ADDENDUM NO. 3

GRANGER-HUNTER IMPROVEMENT DISTRICT, UTAH ANDERSON WATER TREATMENT PLANT PROJECT

November 27, 2024

**ELECTRICAL (E)
 LEVEL 1 POWER PLAN
 1629 WEST 2320 SOUTH**

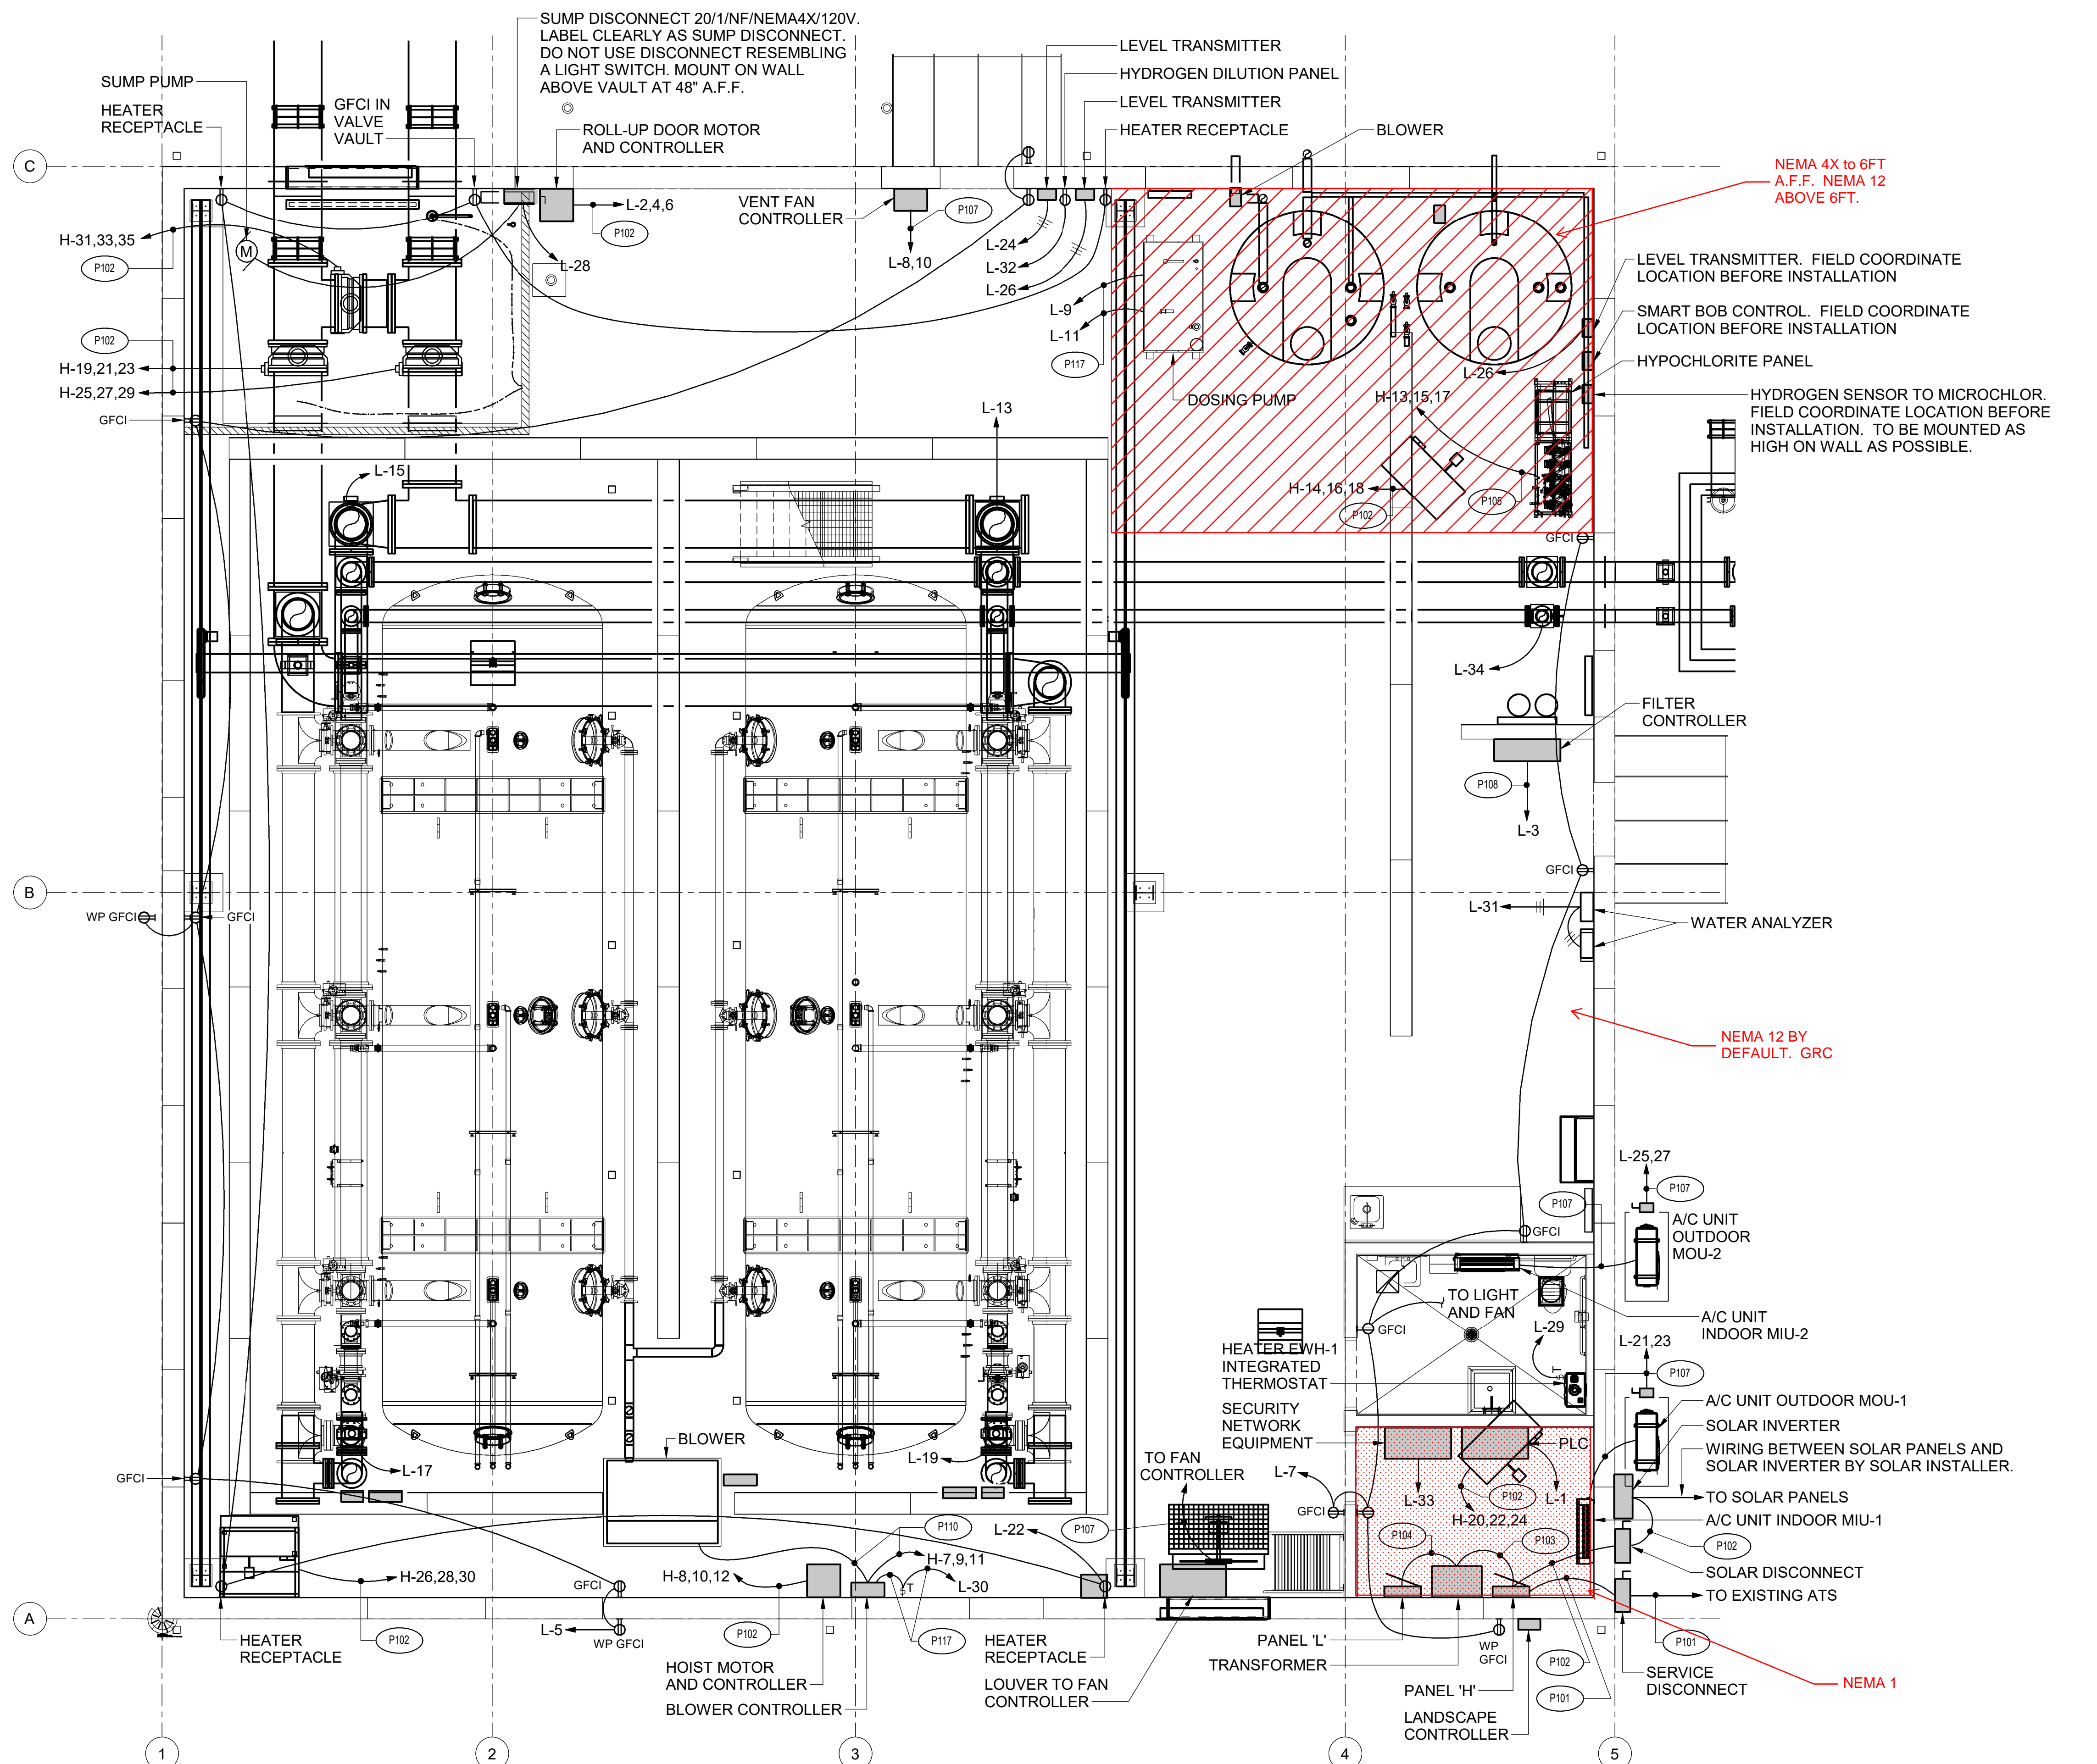
6. Sheet E-104: change wording “WIRING BETWEEN SOLAR PANELS AND SOLAR INVERTER BY SOLAR INSTALLER” to “WIRING BETWEEN SOLAR PANELS AND SOLAR INVERTER BY SOLAR INSTALLER UNDER GENERAL CONTRACTOR”.

8. Sheet E-503: detail 2 and detail 3 change to “BEDDING SAND ~~OR RED CONCRETE AS INDICATED~~”.
9. ~~Sheet E-112: Add sheet E-112 Conduit Classification Plan.~~ It will show the NEMA areas as seen in attached redlined E-104.

- 6. The specifications for conduit contain an area classification table and explanation of each classification (16131), which is helpful, but the drawings do not explain if the entire treatment room is considered one classification, or divided up. Confusing matters is the one-line (E-601) shows the hoist disconnect as NEMA 3R, which is not included in the specs. Is the area around the hypochlorite tank and pump system considered corrosive and wash-down? Is the area surrounding the filters considered NEMA 12, or NEMA 3R? Is the entire room considered NEMA 4X? Please clarify how the treatment room is to be classified.

See the attached Area Classification Sketch on E-104. This is now sheet E-112.
